# INTERIM TECHNICAL EVALUATION REPORT

EVALUATION OF DIESEL GENERATOR FAILURE  
AT SHOREHAM UNIT 1

INTERIM REPORT ON PHASE 1, FAILURE CAUSE EVALUATION

NRC DOCKET NO. 50-322

Figure 1. Torsional Stress and Critical Speeds

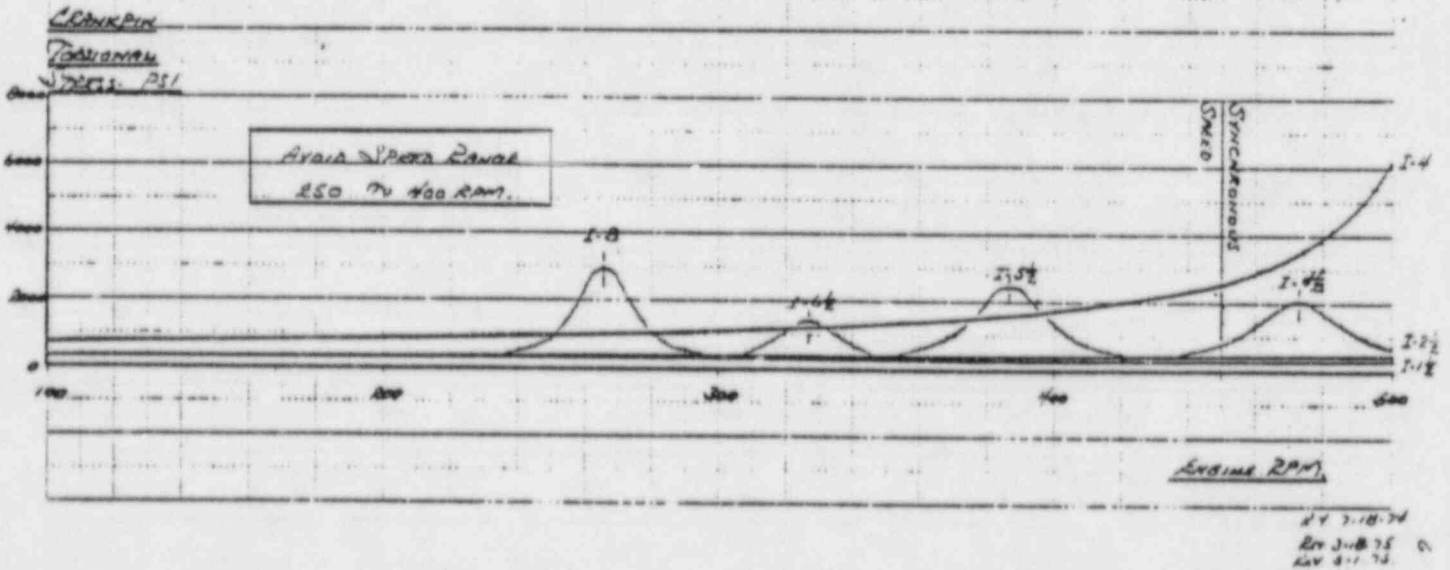
Using its model for the resonant frequencies, TDI calculated the participation of the various orders of known engine excitation and plotted the amplification factors of the more dominant excitation orders as shown in Figure 1, which is a reproduction of the TDI chart from Reference 2. Note that the I-4 (4th order) curve of amplification factor remains the single largest participant, providing more than double the amplitude of the 4 1/2th order during operation at 450 rpm. The excitation frequency of the 4th order is that of 4 times per revolution. This is the firing rate of the cylinders which generates a sharp and dominant excitation. In short, using its analysis, TDI expected to experience a large component of oscillatory torque at 30 Hz (engine firing rate) in the crankshaft. However, a large cyclic torque at 30 Hz is not necessarily bad, provided the associated stress levels in combination with stresses from other sources in the crankshaft are adequately within the endurance limit of the material.

Review of TDI's mass-elastic system revealed that:

- o the generator inertia was exceptionally large
- o the flywheel inertia was only between one-third and one-half that of the generator rotor
- o all other inertias representing crank assemblies, water pump, etc., were very small by comparison.

Thus, while the introduction of the rotor-stator equivalent spring had an exceedingly small effect upon the natural frequencies of the rotor and their dynamic response under the engine excitation, it did define a new mode of vibration not heretofore available from TDI's torsional model. This was essentially a rigid-rotor oscillation of the combined crankshaft, flywheel, and generator rotor system with the rotor-stator spring connecting the rigid-rotor system to the nearly infinite electrical load inertia mentioned previously. The natural frequency (resonance) of this vibratory mode was independently calculated to be approximately 3.0 Hz. This vibration mode contributed to the cyclic variation of power previously observed from the control room to be at 3.75 Hz, which is the frequency at which one complete set of eight cylinders fires, or the rate at which any one cylinder fires. Fortunately, the natural frequency of just under 3.0 Hz was sufficiently far from the 3.75 Hz excitation to prevent large amplitude vibration with resulting large swings in power. Also, the amortisseur windings of synchronous generators provide damping under oscillatory motions to limit amplitude buildup.

For diesel generators that may be coupled to the electrical power grid, TDI should have addressed this electrical-mechanical, rotor-stator coupling.
